METROPOLITAN GOVERNMENT OF NASHVILLE AND DAVIDSON COUNTY

STAFF RECOMMENDATION
2300 10th Avenue South
June 17, 2020

Application: New Construction—Addition
District: Waverly-Belmont Neighborhood Conservation Zoning Overlay
Council District: 17
Base Zoning: R8
Map and Parcel Number: 10513037500
Applicant: S. Mitchell Hodge
Project Lead: Melissa Baldock, melissa.baldock@nashville.gov

3 SITE PLAN
0 1" = 20'-0"

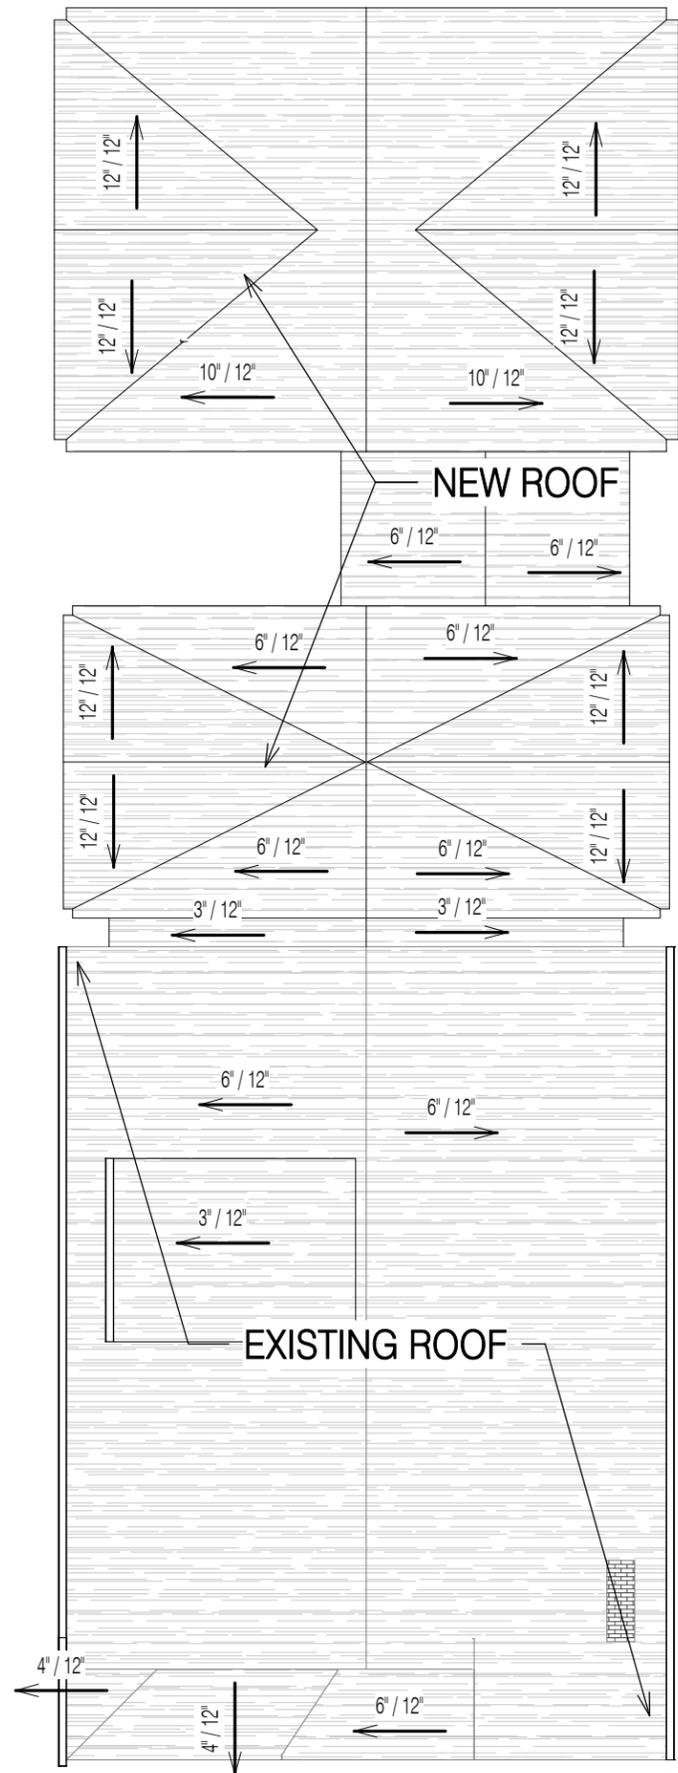
Setback & Rhythm of Spacing: The addition will have side setbacks of at least ten feet (10') facing Waldkirch Avenue, nine feet six inches (9'6") from the right-side property line, and fifteen feet one inches (15'1") from the rear. Base zoning requires that the

addition be at least twenty feet (20') from the rear property line and that the attached garage be at least twenty feet (20') from Waldkirch side property. The project therefore requires setback determinations. The setbacks may be appropriate because the addition is not overly large – it is no taller or wider than the historic house and does not more than double the footprint of the house. Regarding the rear setback, the lot's shallowness and the "alley" on the site makes it challenging to have an addition and a detached garage; the rear setback would be appropriate for a detached garage but not for the attached garage that is proposed. Staff finds that the proposed rear setback is appropriate because of the peculiarities of the lot and because the addition will still allow for sufficient space for cars to access the private drive on the property of 2300 10th Avenue South.

Regarding the setback facing Waldkirch Avenue, although Codes requires a twenty-foot (20') setback from the side street, MHZC has approved ten foot (10') setbacks for corner lots like this one when the addition is no wider than the historic house, as is the case for this project. The setback will not negatively impact the historic character of the house or the district.

Staff finds that the proposed setbacks will not affect the rhythm of spacing of houses and will be appropriate for the house and the site. Staff therefore finds that the proposed setbacks meet Sections III.C. and IV. of the design guidelines.

My name is Casey Dycus and I own 919 Waldkirch Ave in 12th South. Me and my husband, Graden Dycus, vote no and are opposed to adjusting the setback of 15' where there is historic precedence.

LOWER, MAIN LEVEL &
ROOF PLANS

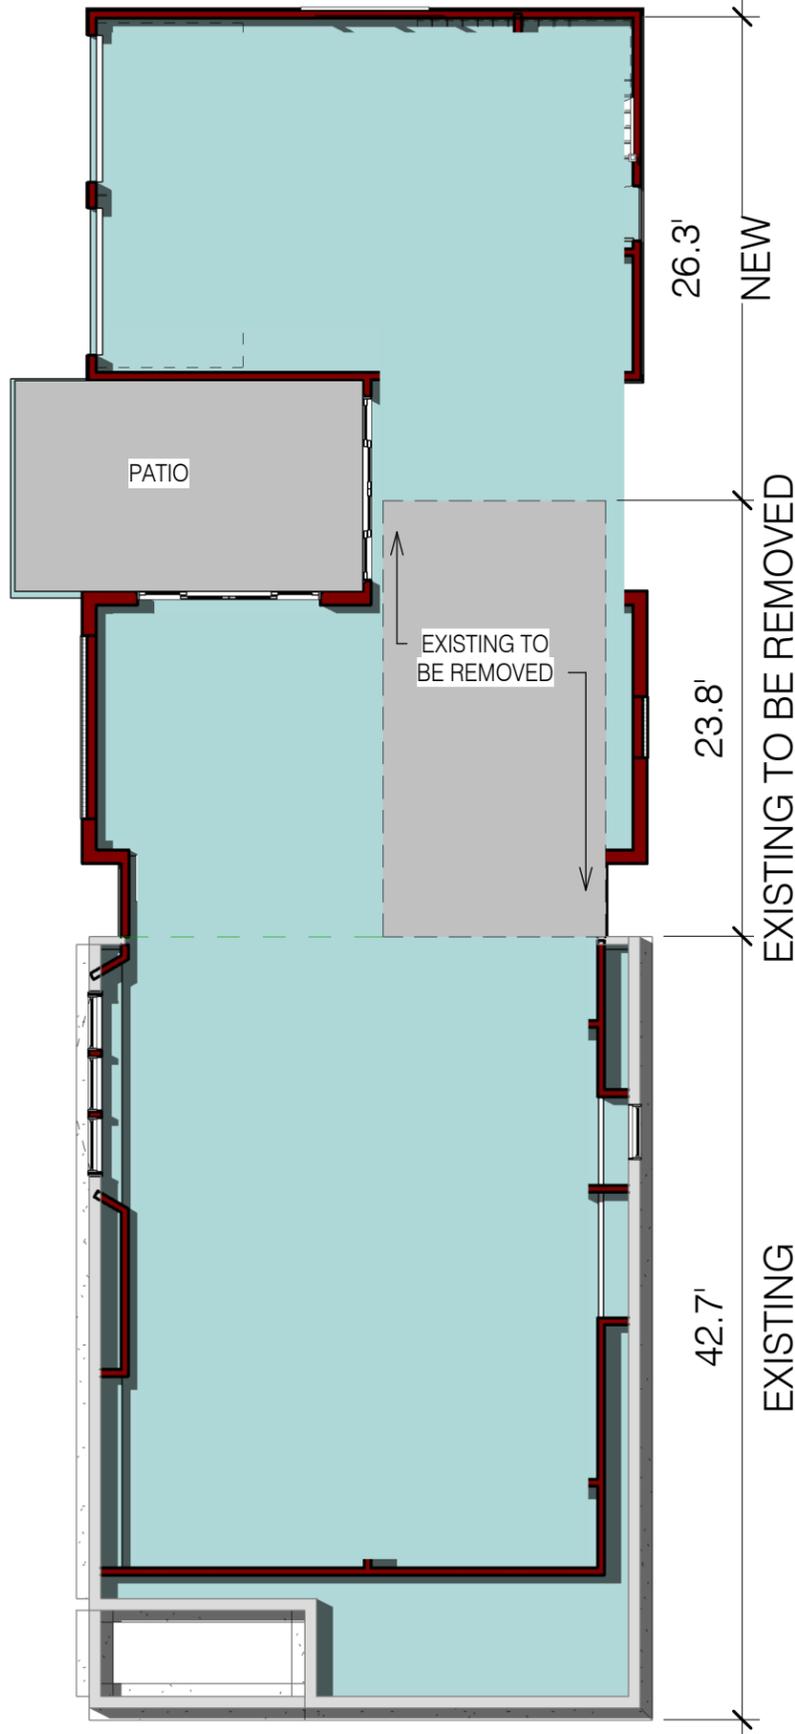
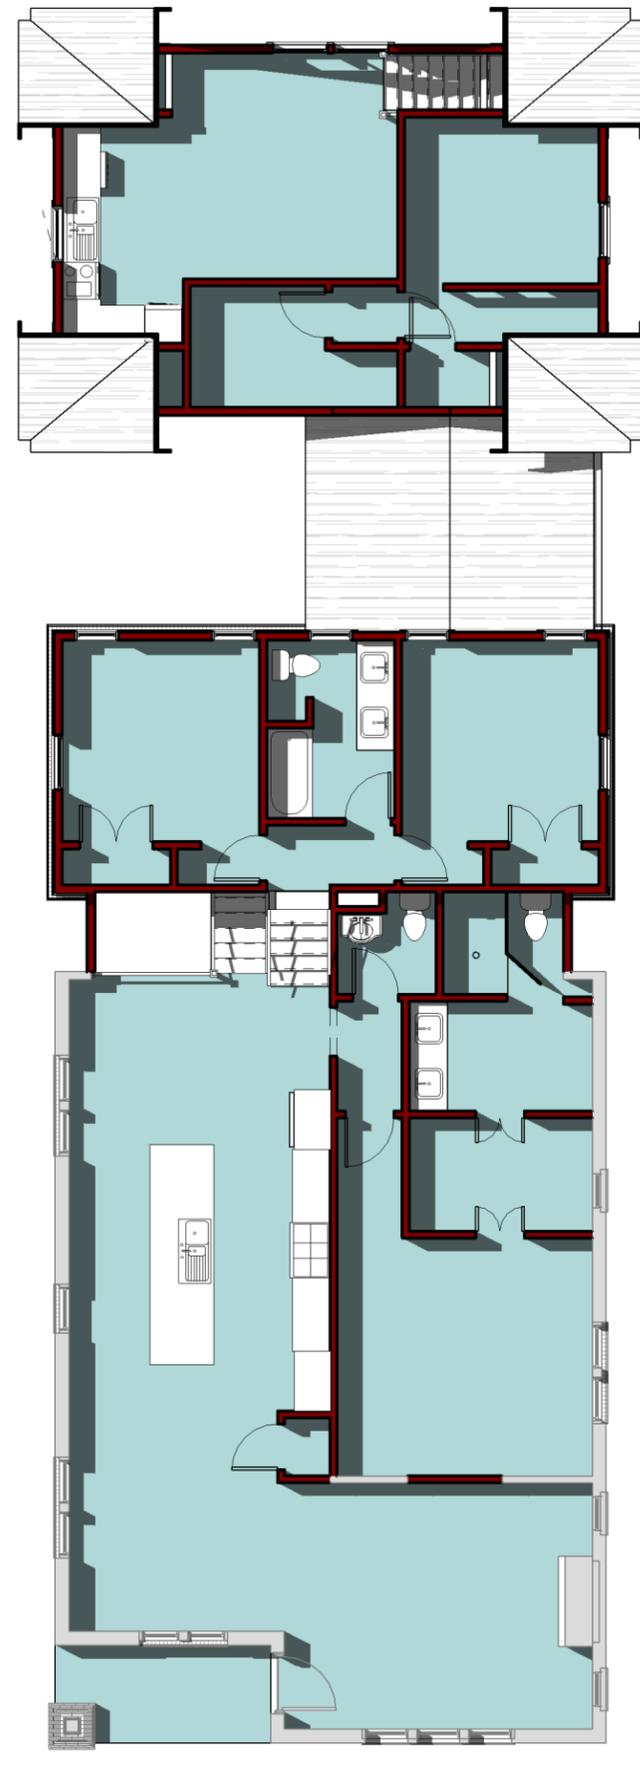
Height & Scale: The addition will be no taller than the historic house. The addition will be inset two feet (2') from each of the back corners for a depth of approximately four feet (4'). After the inset, the addition steps back out to line up with the side walls of the historic house. After an additional depth of approximately fifteen feet (15'), there is a narrower portion, before the attached garage portion. In all, the addition will add approximately one thousand, three hundred forty-five square feet (1,345 sq. ft.), which has a current square footage of approximately fifteen hundred square feet (1,500 sq. ft.).

The addition includes an attached garage. The attached garage is largely located at the basement level, per the design guidelines. In addition, the lot is shallow at one hundred and thirty-seven feet (137') in depth, and is rendered even more shallow by the fact that the private drive that services this east side block of 10th Avenue South between Waldkirch and Caruthers is not actually a mapped alley, but part of the private properties. Therefore, approximately the last ten feet (10') of the property cannot be built upon without severing the other lots on this block from access from Waldkirch. Practically, the lot is more like one hundred and twenty-seven feet (127') deep when the private drive is taken into consideration.

Roof form: The addition will tie into the historic house with a gable form that is lower and separate than the main roof form. The main roof form of the addition is a cross gable; the garage element also has a cross gable. The addition includes a shed dormer on the main historic roof of the house. The new dormer meets all the design guidelines for side dormers – it is inset at least two feet (2') from the wall below, is mainly composed of windows on its front face, and is scaled appropriately.

Staff finds the roofs of the proposed addition will be compatible with the historic house, and that the project meets Sections III.E and IV.C of the design guidelines.

Appurtenances & Utilities: The location of the HVAC and other utilities was not noted in the plans. Staff asks that the HVAC be located on the rear façade, or on a side façade beyond the midpoint of the house.

Recommendation: Staff recommends approval of the proposed addition at 2300 10th Avenue South with the conditions that staff approve all windows and doors, the roof shingle color, and the location of all utilities, finding that the proposal meets the design guidelines for the Waverly-Belmont Neighborhood Conservation Zoning Overlay.

ELEVATIONS
2
PROJECT 2019
DATE 06.04.20

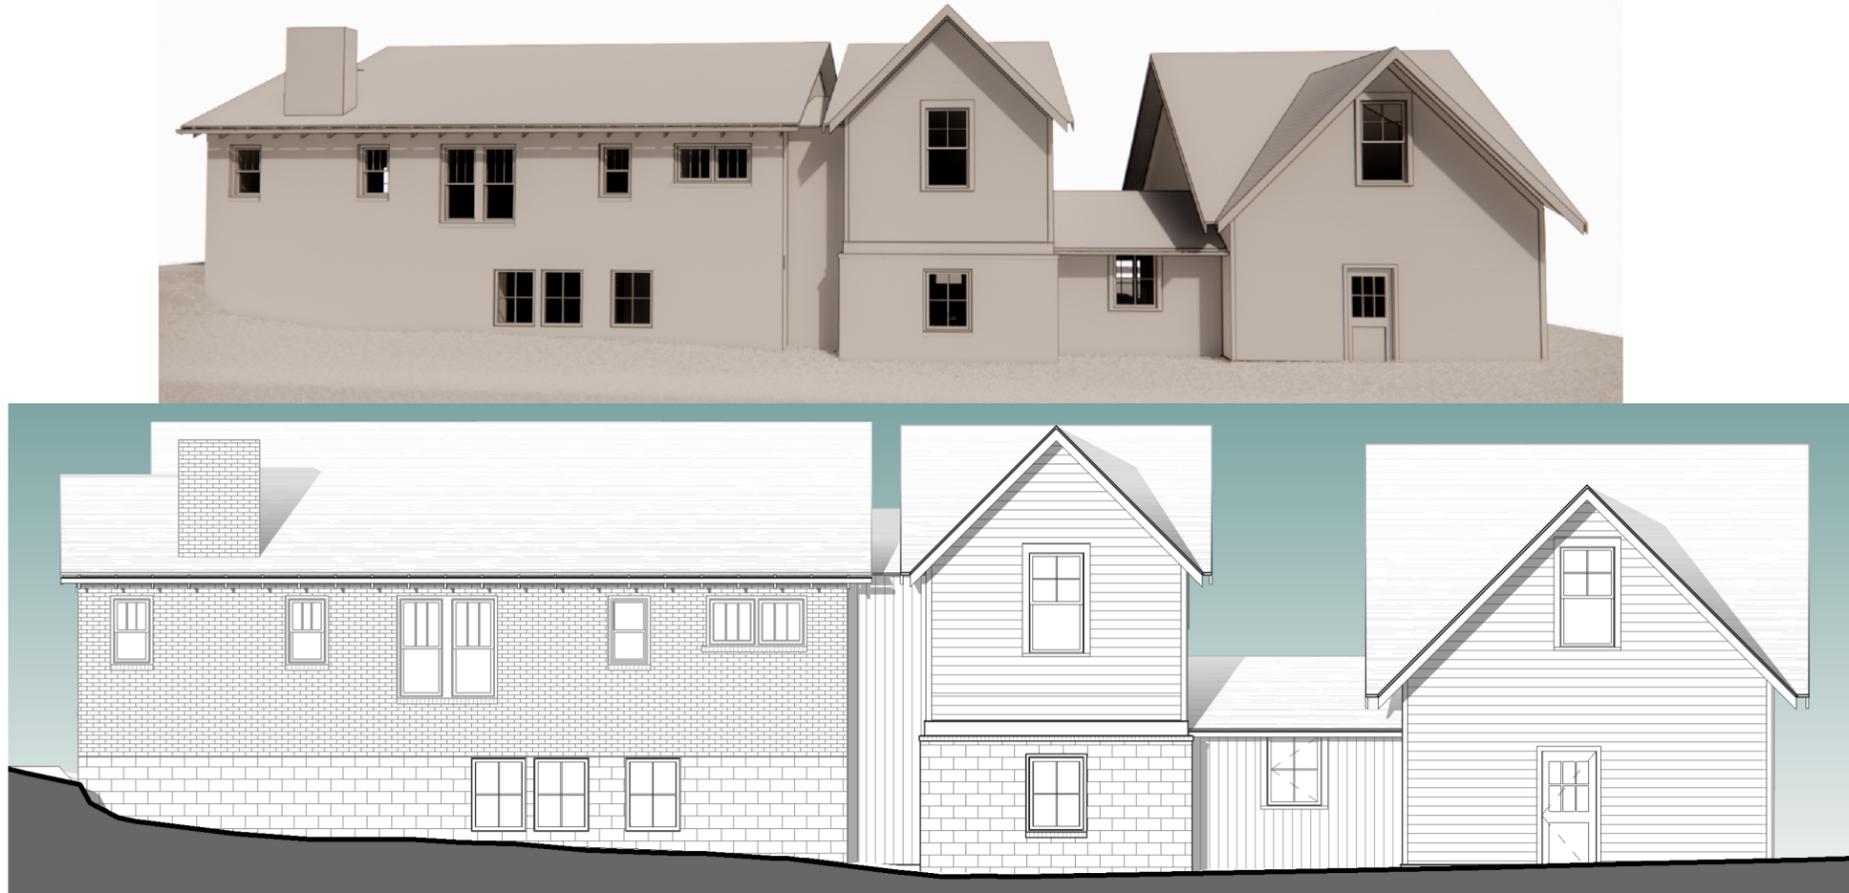
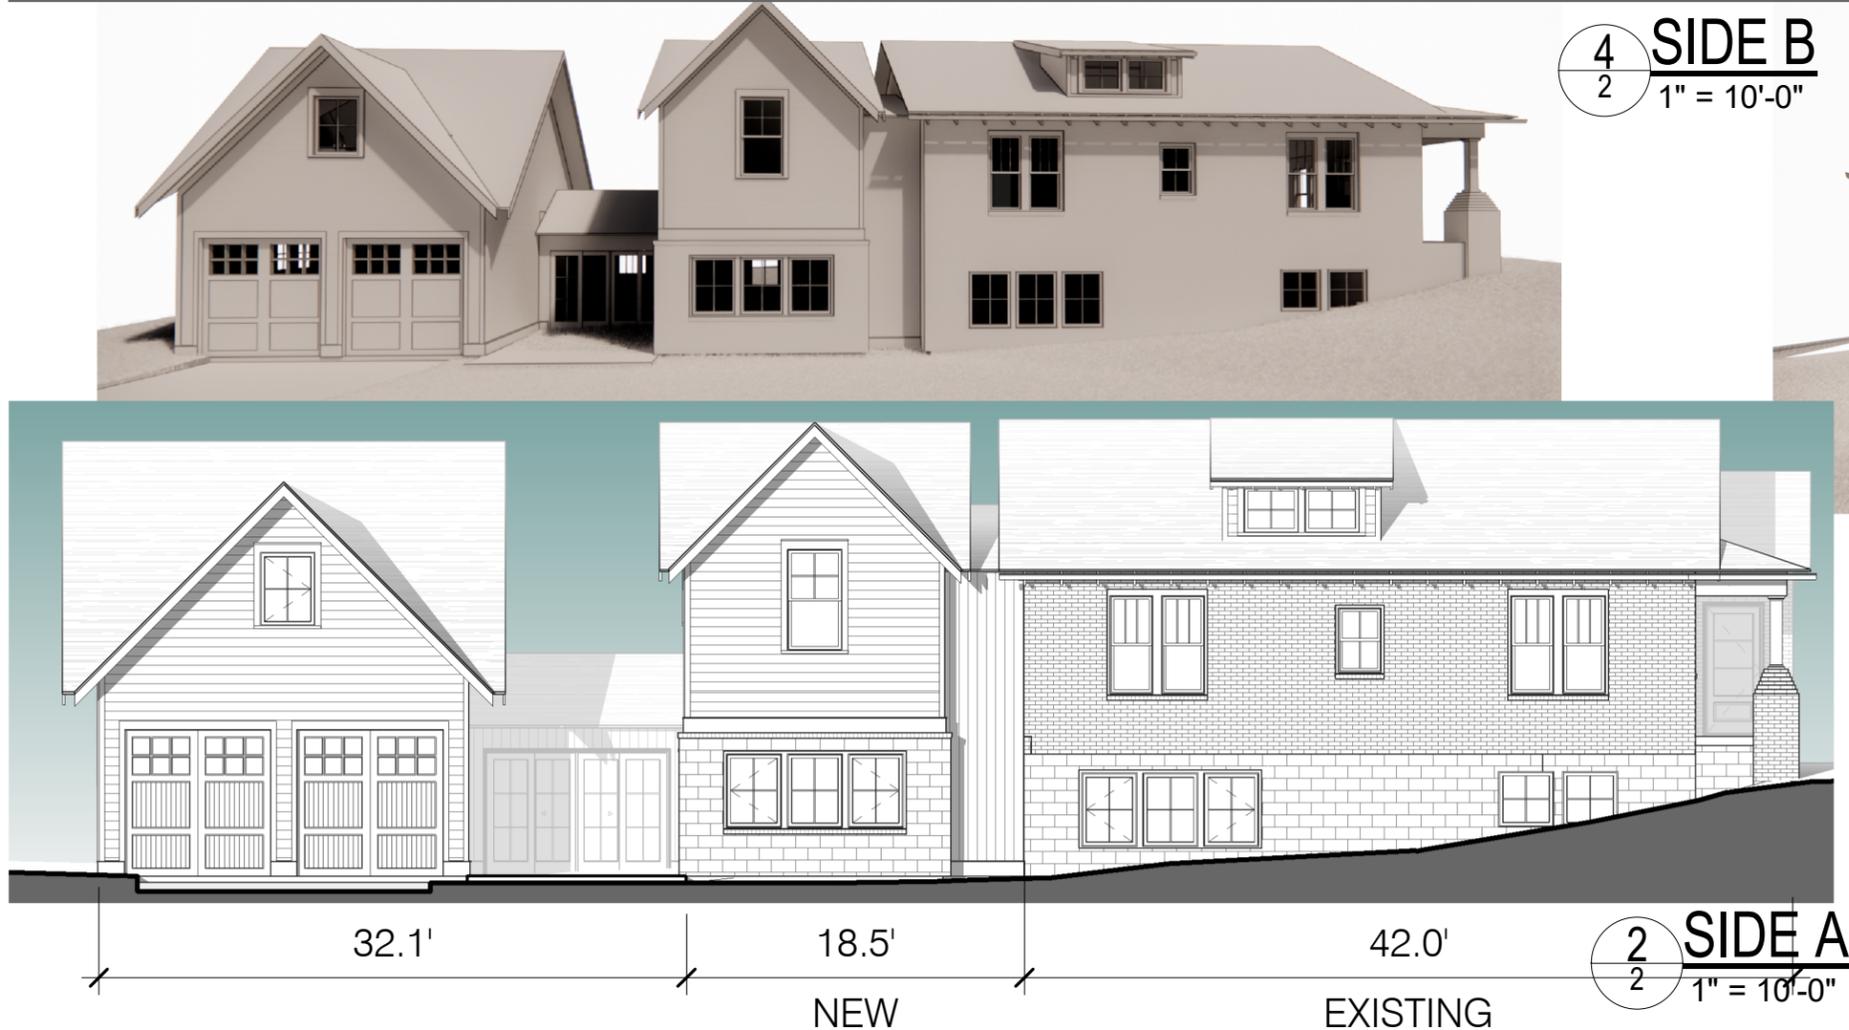
Orientation: The addition will not alter the historic house's orientation towards 10th Avenue South. The attached garage is oriented towards the side street, Waldkirch Ave, and will use an existing curb cut for access. Staff finds this to be appropriate since the curb cut and a parking pad are existing.

Proportion and Rhythm of Openings: The only changes to the windows on the existing house indicated on the plans were those at the basement level which are appropriate. The addition's windows are generally twice as tall as they are wide, and there are no large expanses of wall space without a window or door opening. The garage doors facing Waldkirch Avenue are two separate garage bays, which is appropriate.

Staff finds the project's proportion and rhythm of openings to meet Section III.G. of the guidelines.
